Wall Building Conference Center Renovation Coastal Carolina University

February 20, 2024

ADDENDUM NO. 1

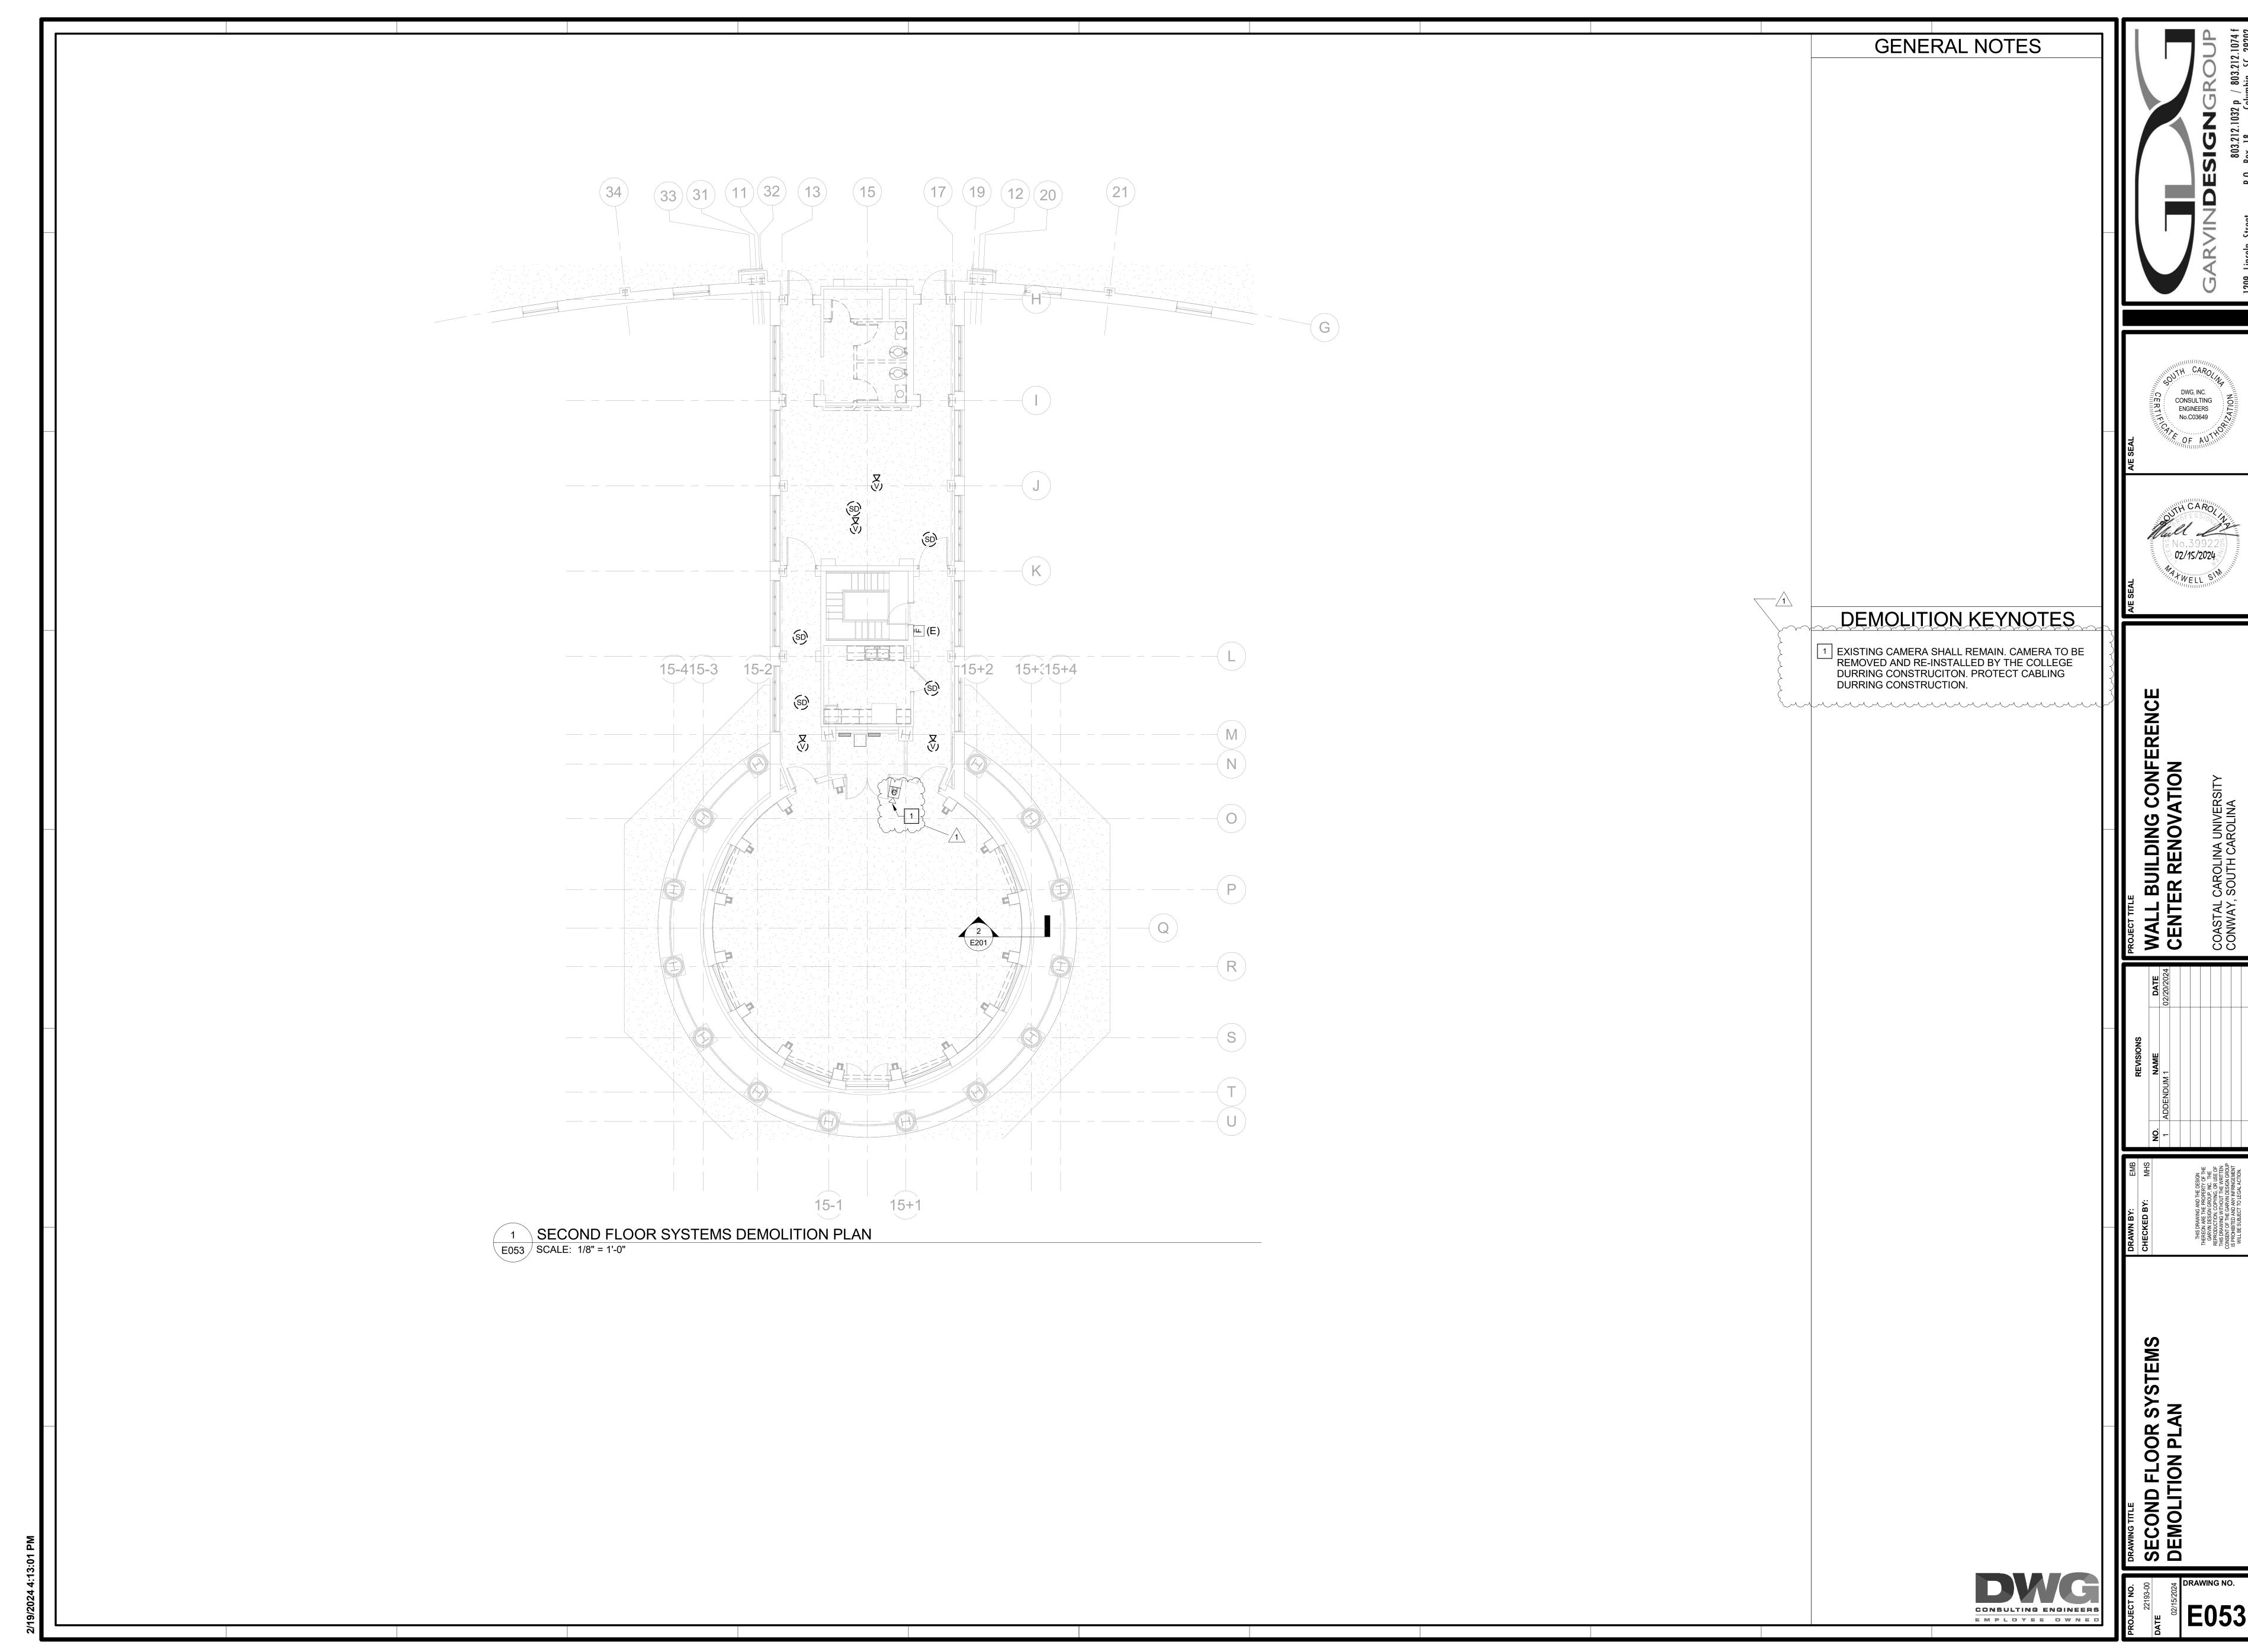
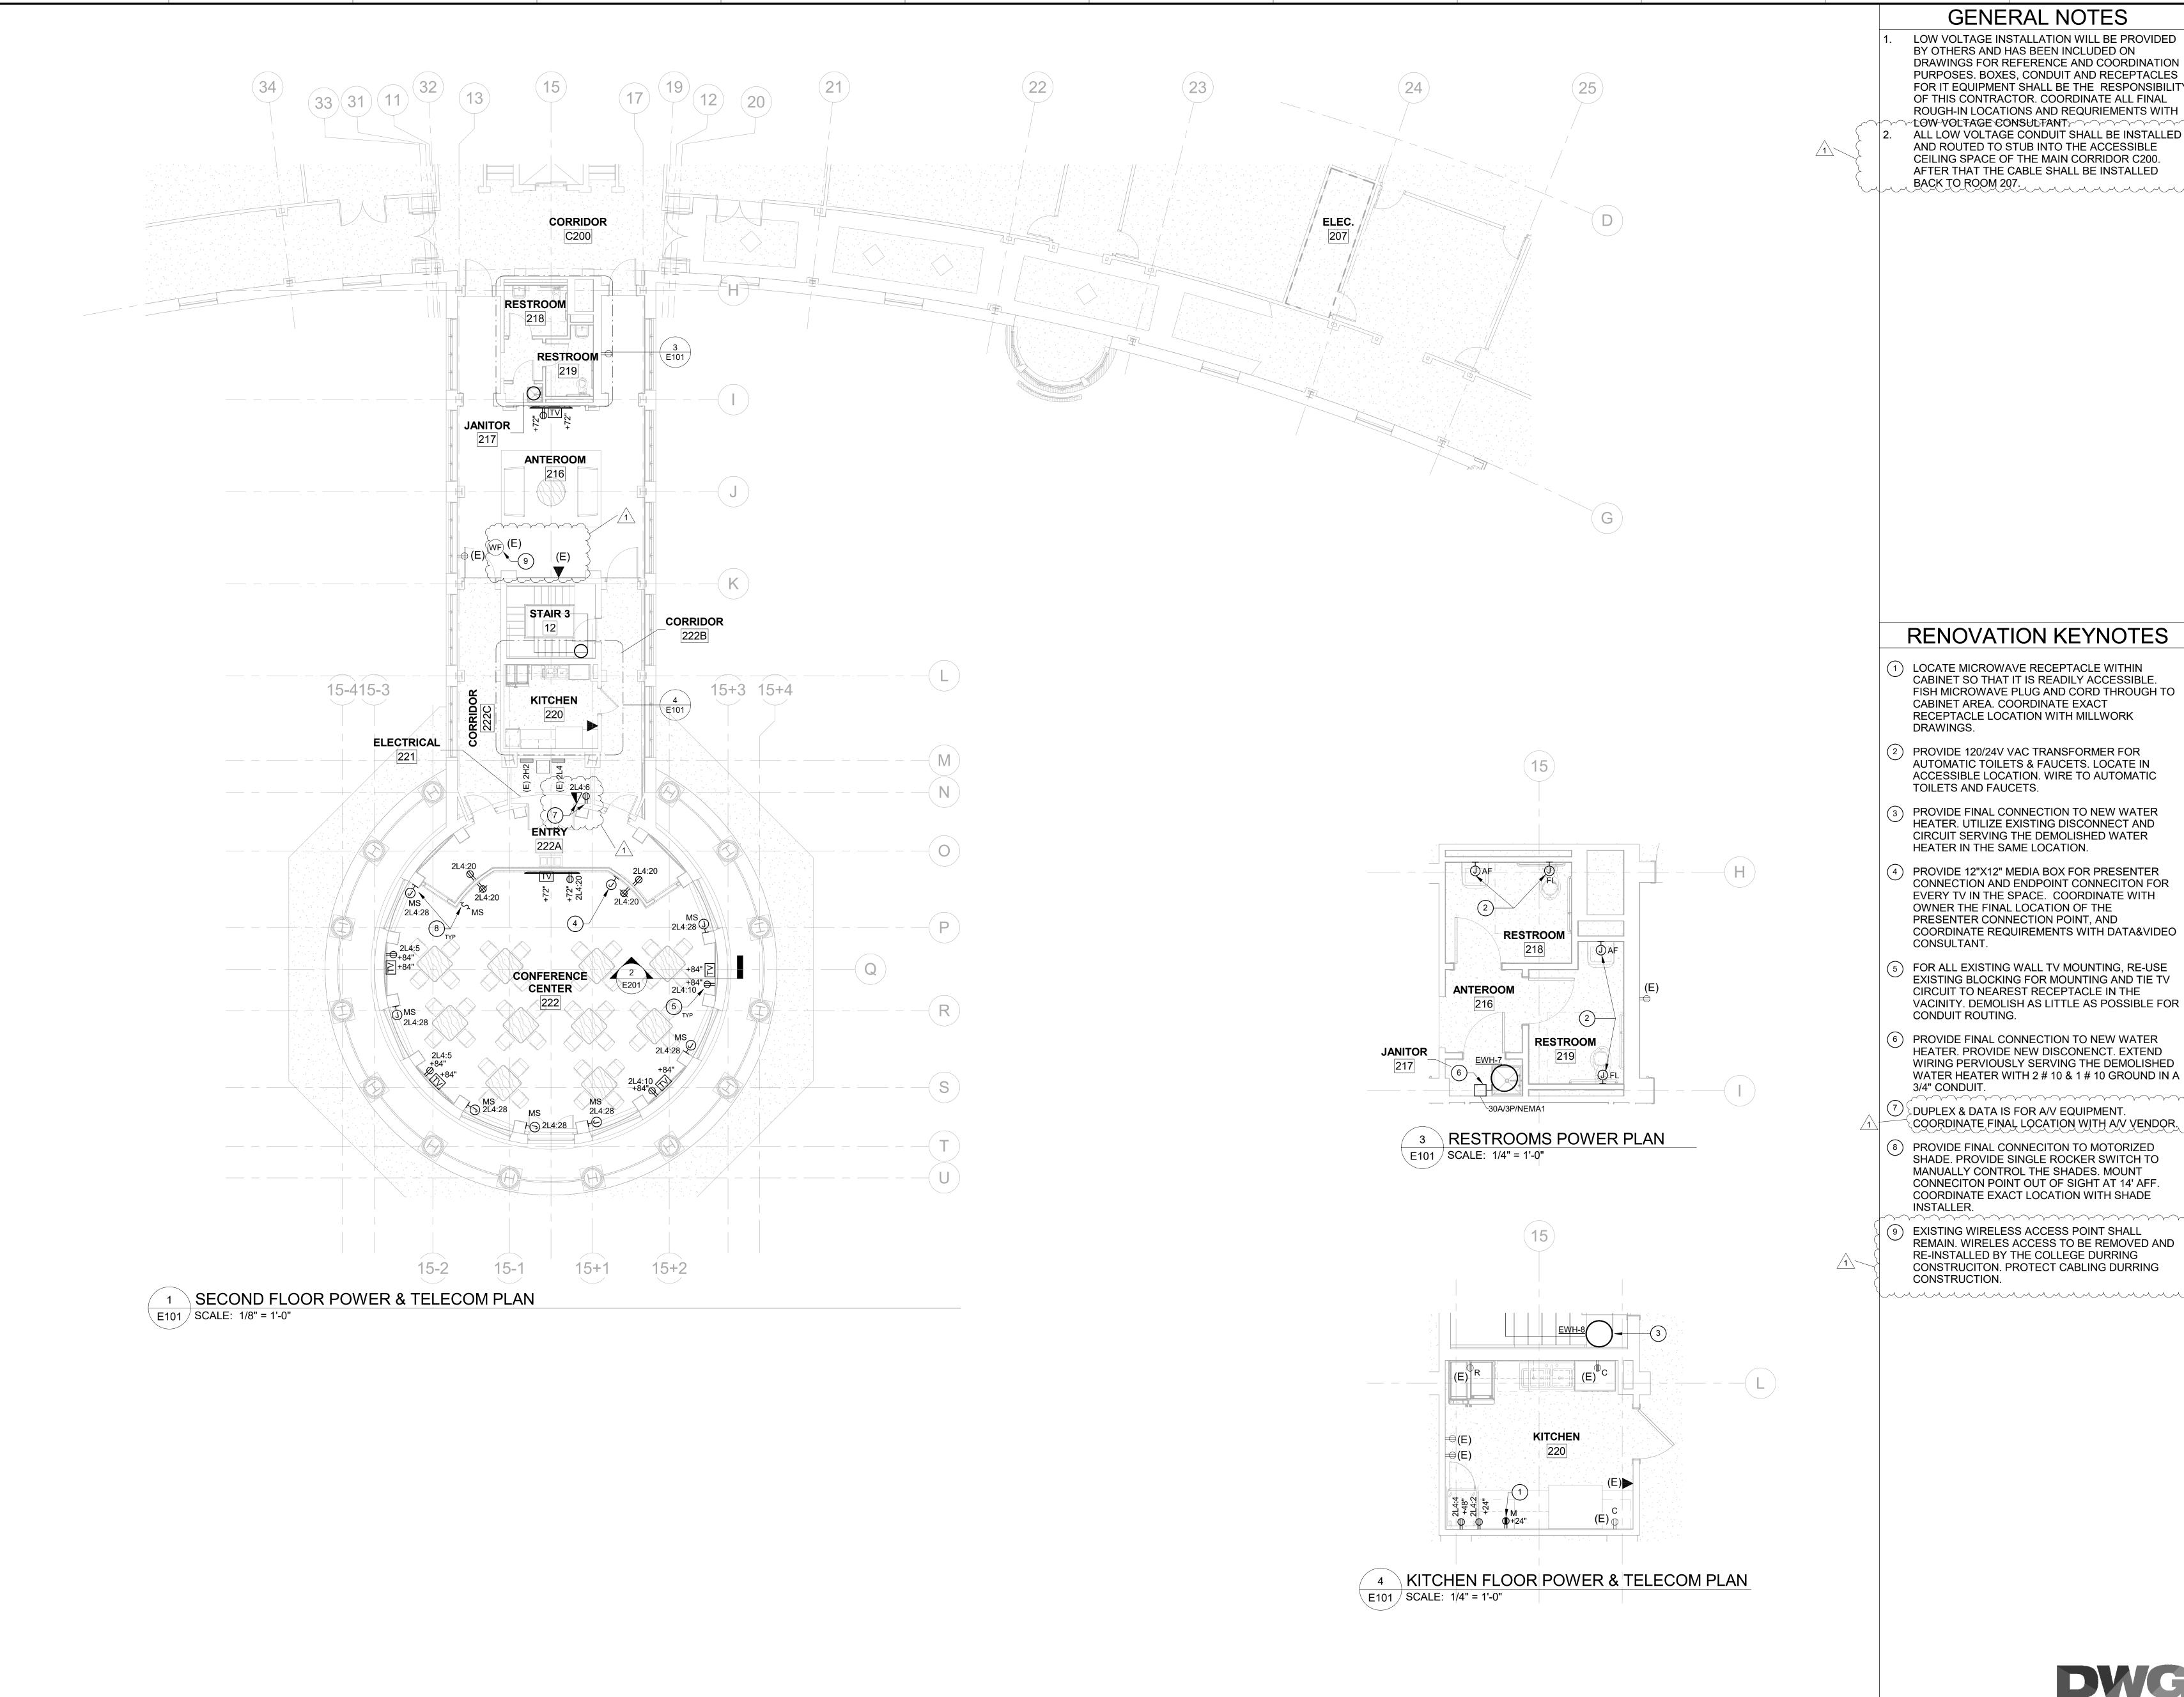
5.	Revision: Reference Drawing E101:					
	a. Clarified routing of low voltage rough-in.b. Modified AV Rack infrastructure in Electrical 221.c. Addressed Wireless Access Point in Anteroom 216.

LOW VOLTAGE INSTALLATION WILL BE PROVIDED BY OTHERS AND HAS BEEN INCLUDED ON DRAWINGS FOR REFERENCE AND COORDINATION PURPOSES. BOXES, CONDUIT AND RECEPTACLES FOR IT EQUIPMENT SHALL BE THE RESPONSIBILIT OF THIS CONTRACTOR. COORDINATE ALL FINAL ROUGH-IN LOCATIONS AND REQURIEMENTS WITH ~LOW-VOLTAGE CONSULTANT.~~~~~ ALL LOW VOLTAGE CONDUIT SHALL BE INSTALLED AND ROUTED TO STUB INTO THE ACCESSIBLE CEILING SPACE OF THE MAIN CORRIDOR C200. AFTER THAT THE CABLE SHALL BE INSTALLED BACK TO ROOM 207.

- EXISTING WIRELESS ACCESS POINT SHALL REMAIN. WIRELES ACCESS TO BE REMOVED AND RE-INSTALLED BY THE COLLEGE DURRING CONSTRUCITON. PROTECT CABLING DURRING CONSTRUCTION.

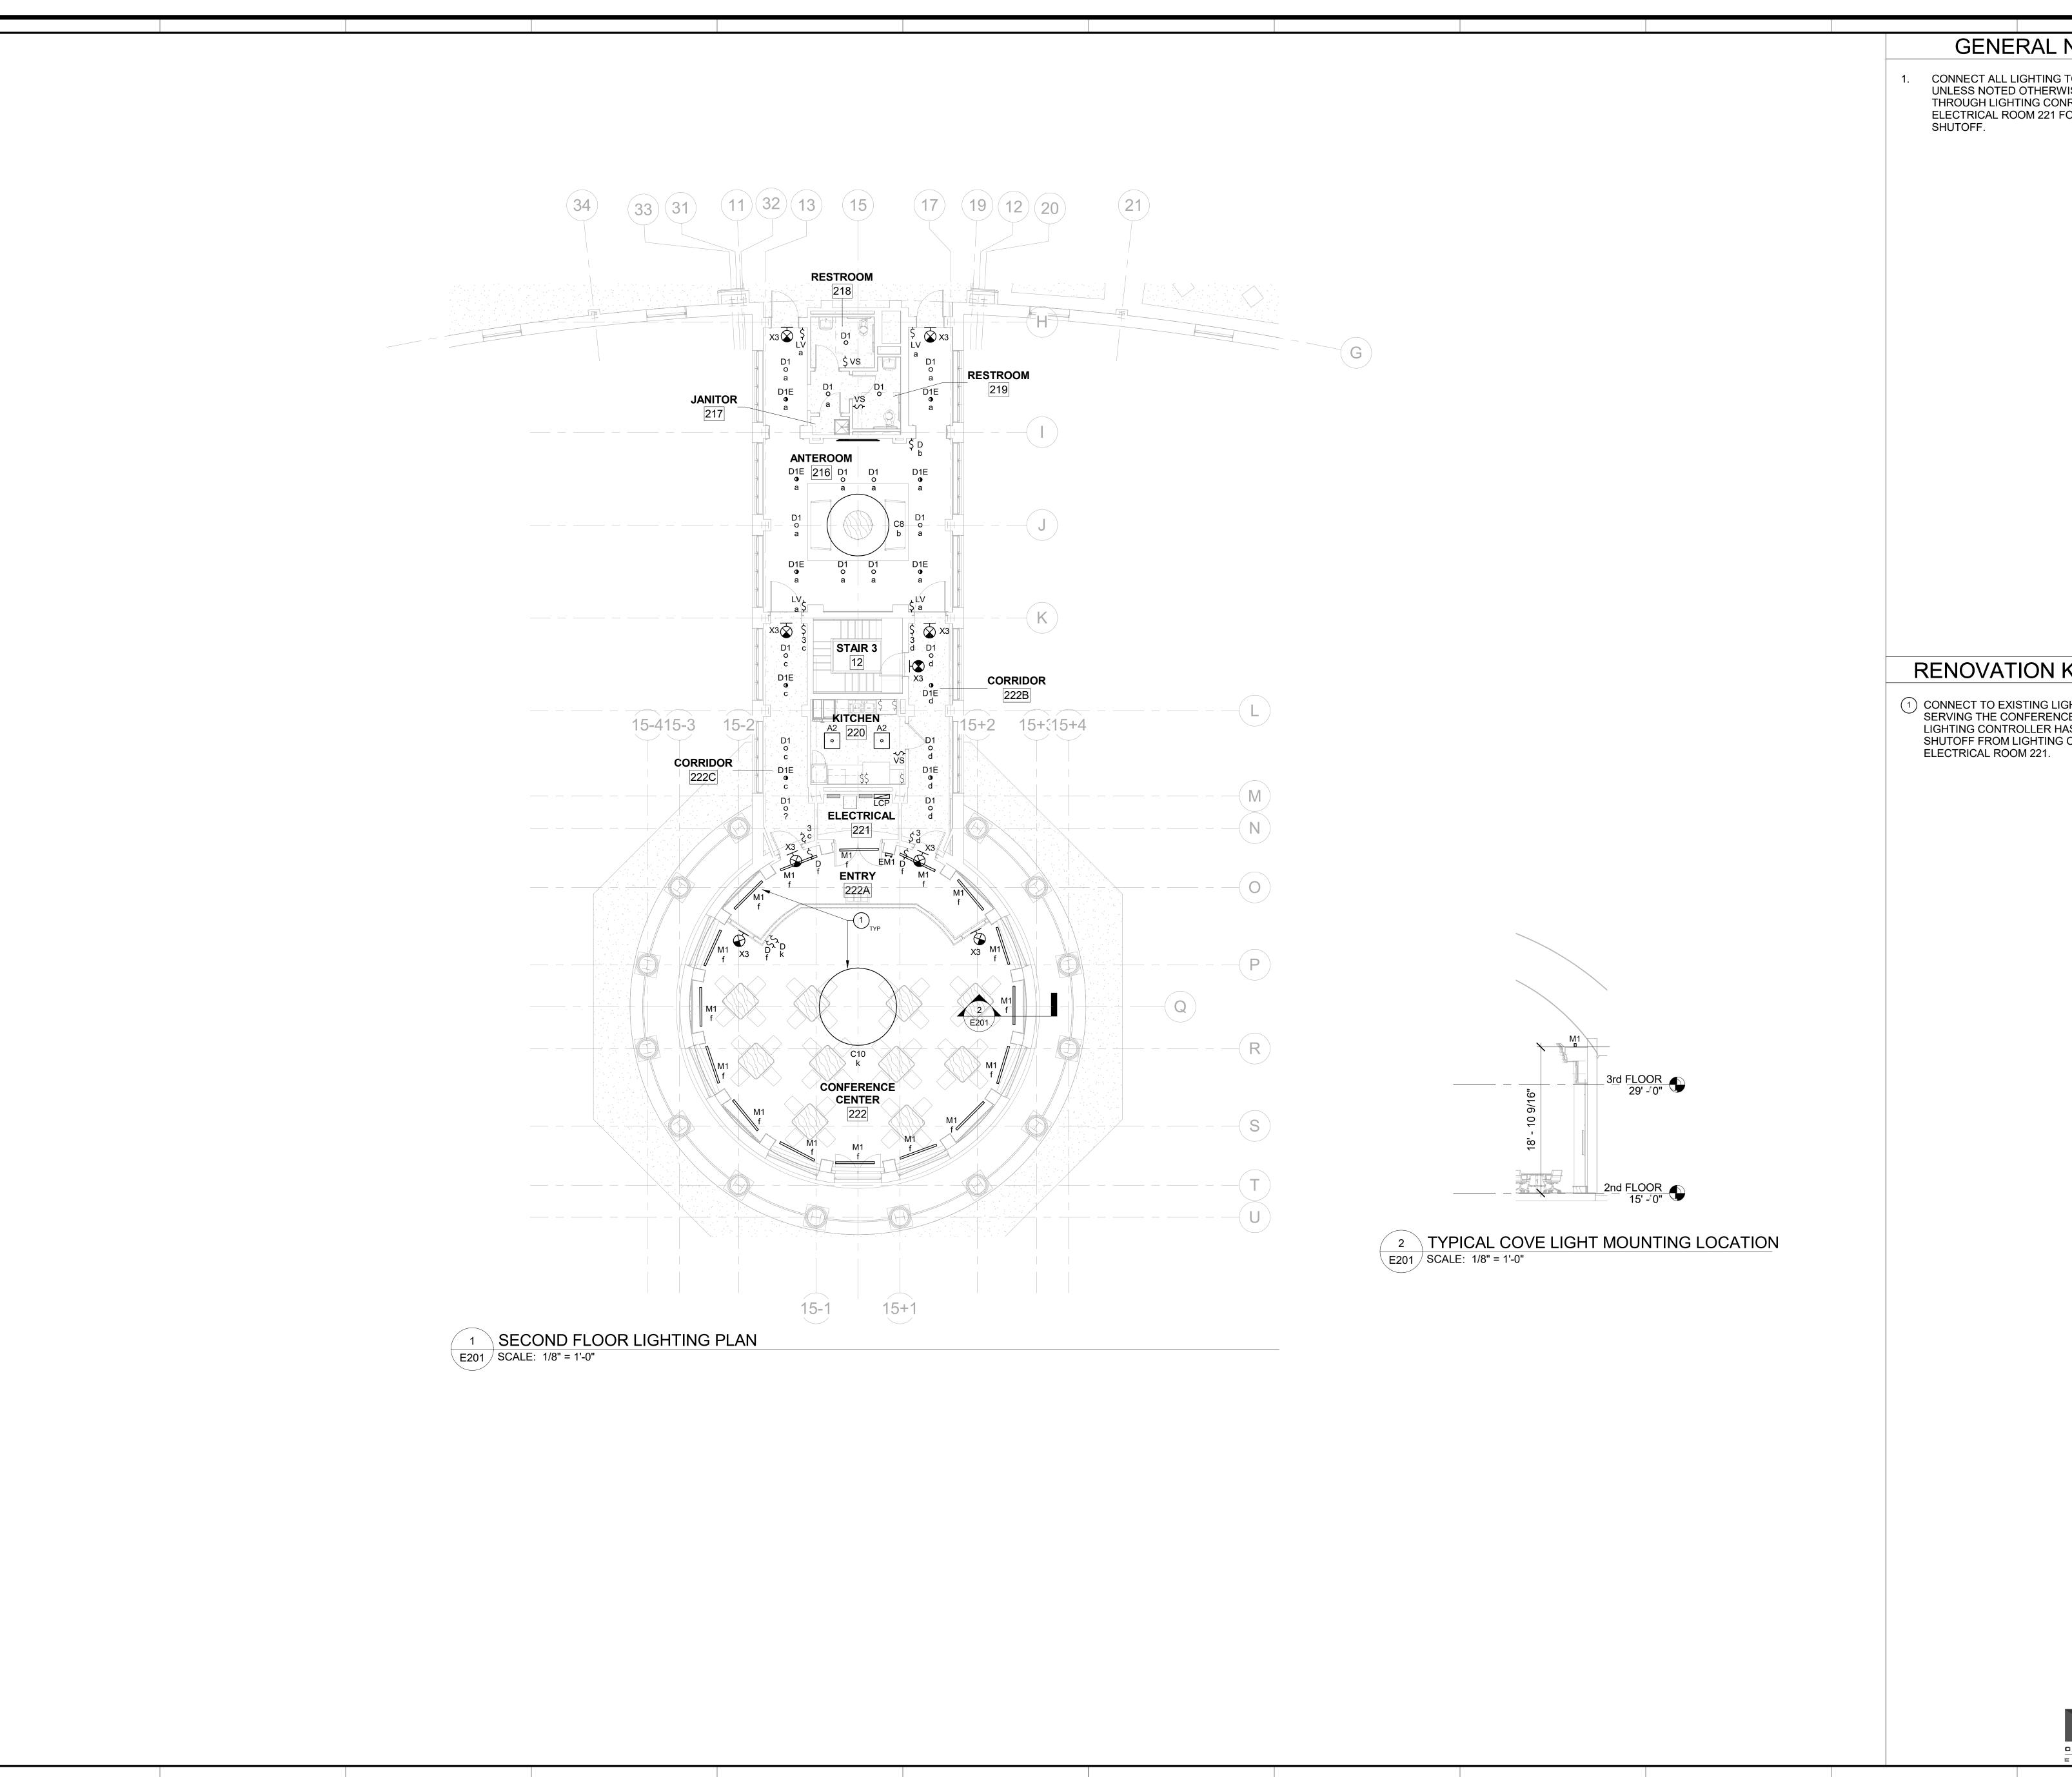
6.	Revision: Reference Drawing E201: Removed reference to 'OSE Comments" in Titleblock.					
7.	Revision: Reference Drawing E301: Clarified camera scope in Entry 222A.
